# Microcomputer Technical Information

QB-78K0MINI 78K0 Series On-Chip Debugging Emulator  Usage Restrictions		Document No.	ZBG-CD-04-0068	1/1
		Date issued	September 24, 2004	
		Issued by	Development Tool Group Multipurpose Microcomputer Systems Division 3rd Systems Operations Unit NEC Electronics Corporation	
Related documents	QB-78K0MINI User's Manual: U17029EJ2V0	Notification classification	<input checked="" type="checkbox"/>	Usage restriction
			<input type="checkbox"/>	Upgrade
			<input type="checkbox"/>	Document modification
			<input type="checkbox"/>	Other notification

## Notes on Using QB-78K0MINI

Figure 5-1. Timing of Target Reset

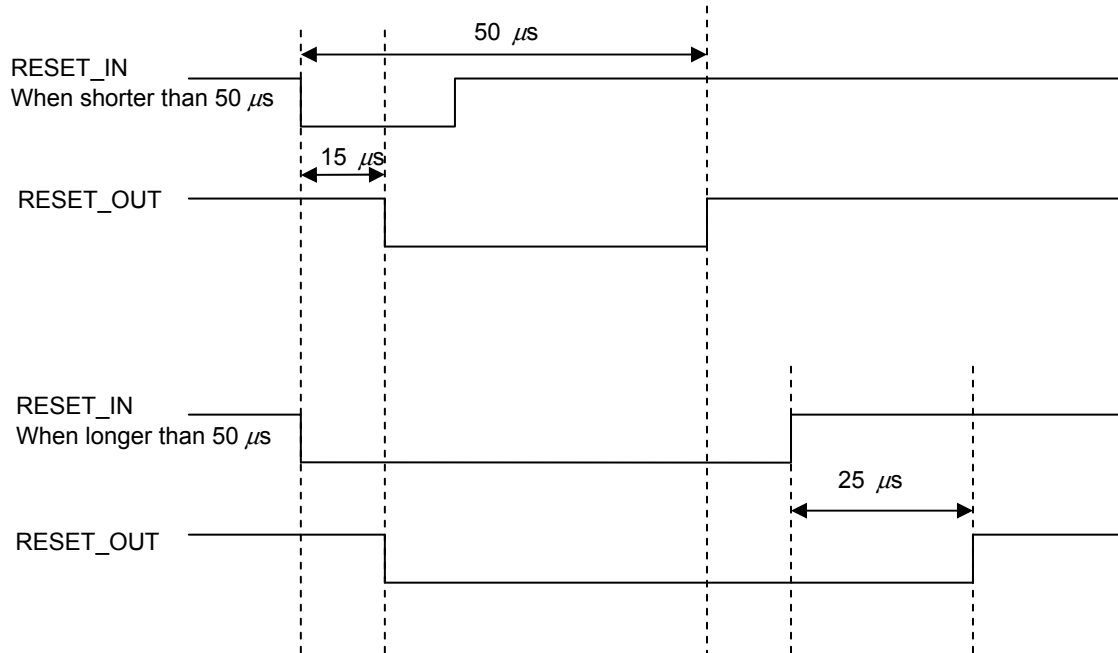
Replace the contents of **CHAPTER 5 RESTRICTIONS** with the following.

(1) A delay period of about 50  $\mu\text{s}$  from cancellation of a target reset (RESET\_IN) to cancellation of a target device reset (RESET\_OUT) (the period from when the target reset (RESET\_IN) becomes low to when the target device reset (RESET\_OUT) becomes high) is required for mode setting.

See Figure 5-1 below.

(2) A delay period of about 25  $\mu\text{s}$  is required from input of a target reset (RESET\_IN) to when the target device is reset (RESET\_OUT).

See Figure 5-1 below.
